Planning App Ref:	PL/2026/02266
Service Ref:	Drainage
Date:	22/07/2026

Full planning permission for erection of 9 residential dwellings, access, parking, gardens, landscaping and associated works.

Land south of, Park Street, Warminster

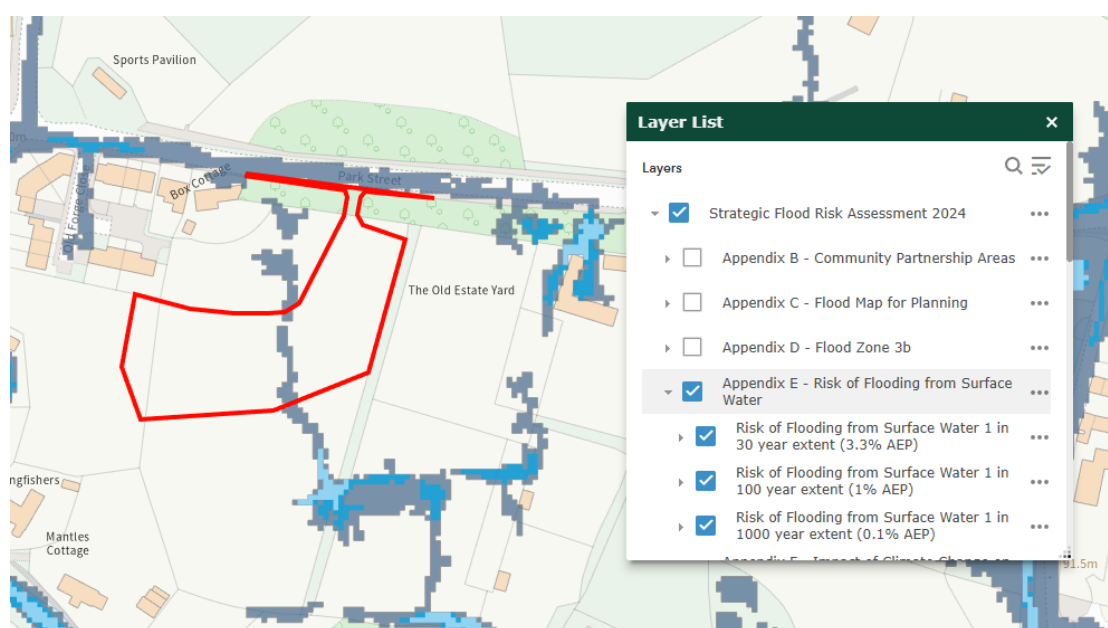
The Wiltshire Council Strategic Flood Risk Assessment, [SFRA Data Explorer](#), has indicated that the site is located within Flood Zone 1 and has a low level of risk from fluvial flooding. The site has a low level of risk from surface water flooding and there is small portion at centre of the site and the access road located in the front of the site falling within the 1 in 100-year flood extent.

SFRA mapping identifies the site as having a medium risk of groundwater flooding.
